AS-BUILT/
CONSTRUCTED

2 SPAN (91'-7 1/8" 91'-7 1/8") TWIN BRIDGES
PREFABRICATED CONTECH BRIDGES WITH STEEL WIDE FLANGE GIRDERS
MESA TOP DRIVE SOUTH OVER NORTH BEAVER CREEK
24'-0" ROADWAY CURB TO CURB
45'-00'00" SKEW
5'-6" SIDEWALK, THREE BEAM RAIL WITH SAFETY RAIL ABOVE SIDEWALK
6' CURB, THREE BEAM

DESIGNED BY: HMR	PROJECT TITLE FOREST LAKES BRIDGES	PROJECT LOCATION MONUMENT, CO
DRAWN BY: AJM		
PROJECT MANAGER: HMR	SUMMARY OF QUANTITIES	STRUCTURE JOB:
DATE: 7/12/22		SHEET NO. B02

FOUNDATION LAYOUT

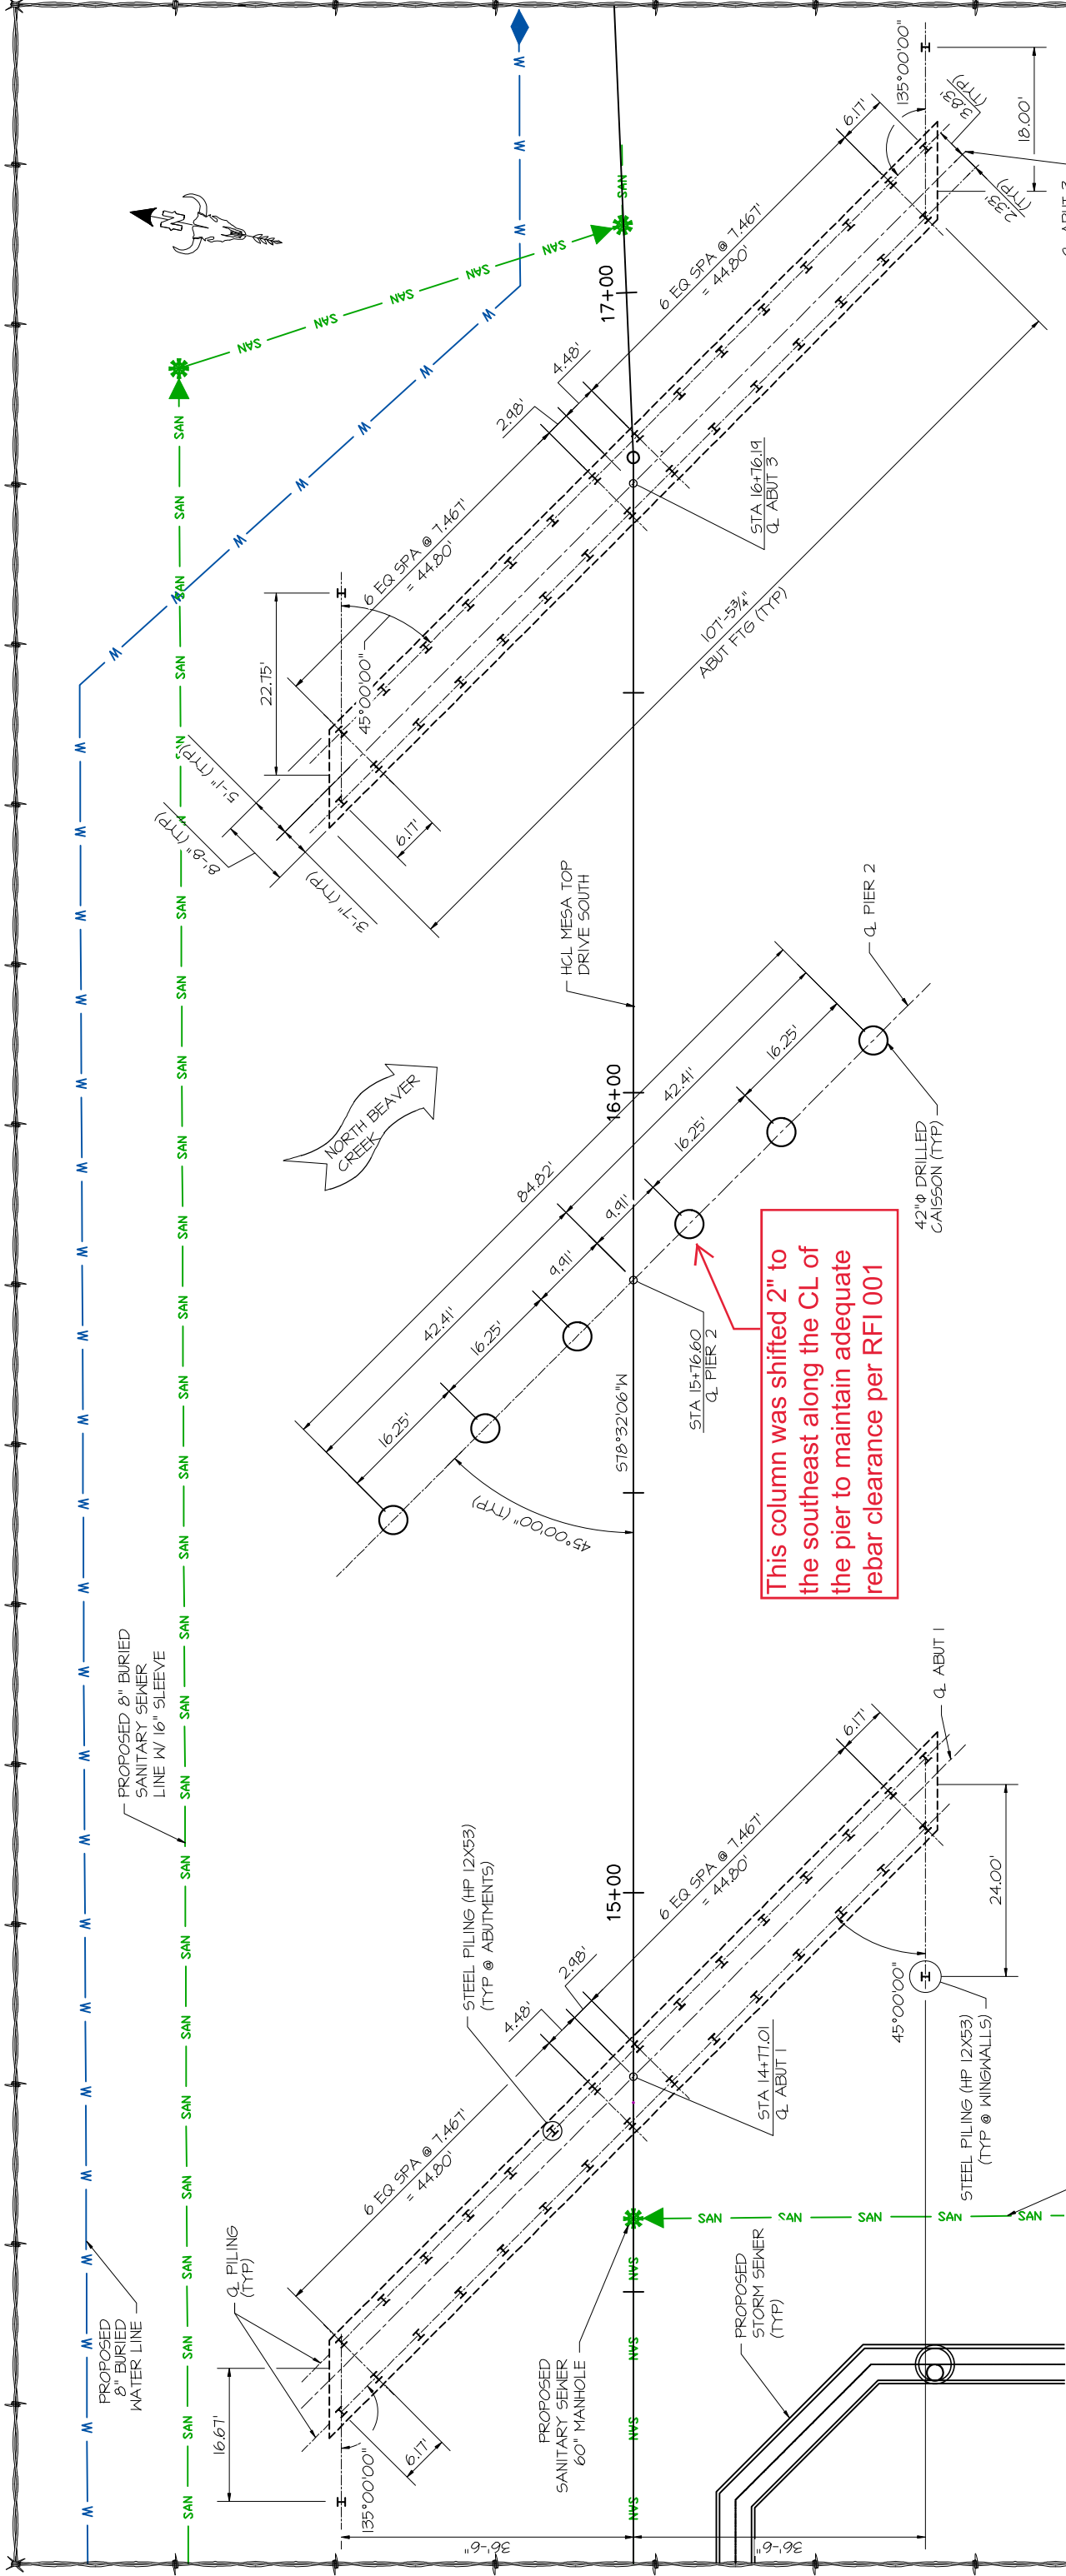
Per the pile driller, piles were embedded +/- 3' into bedrock. Piles were driven until the N count = 120 blows.

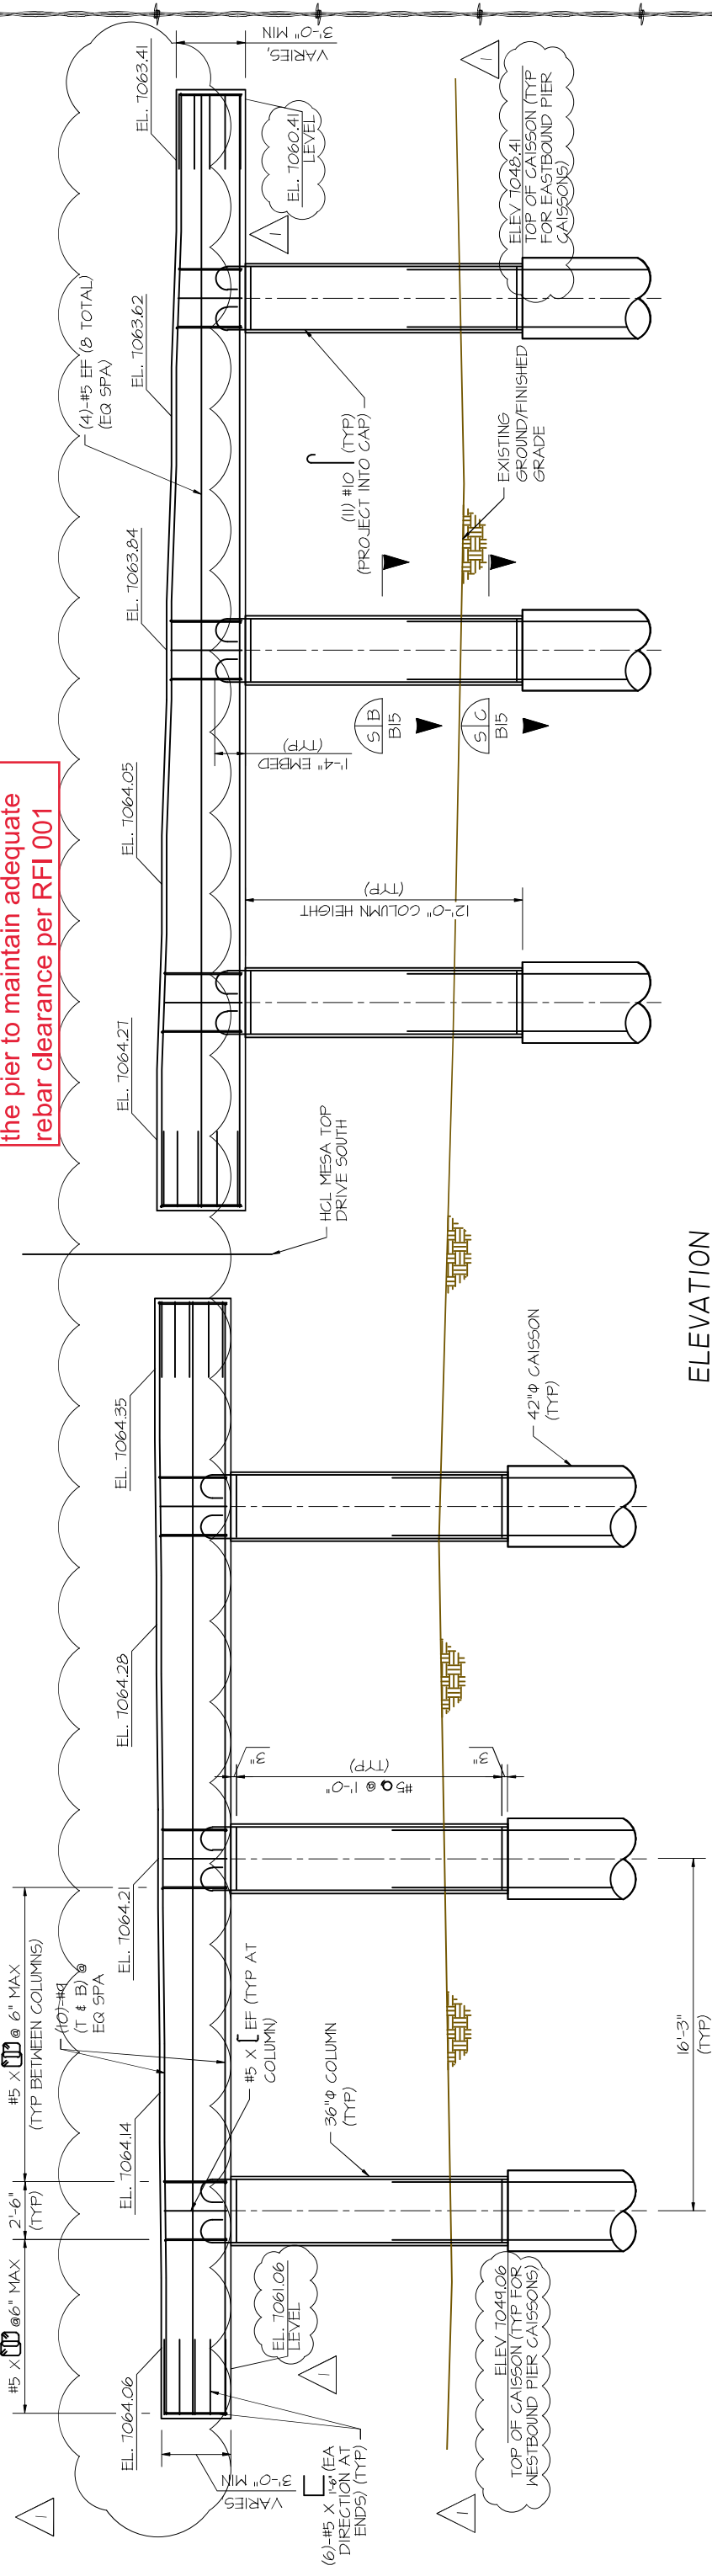
This column was shifted 2" to the southeast along the CL of the pier to maintain adequate rebar clearance per RFI 001
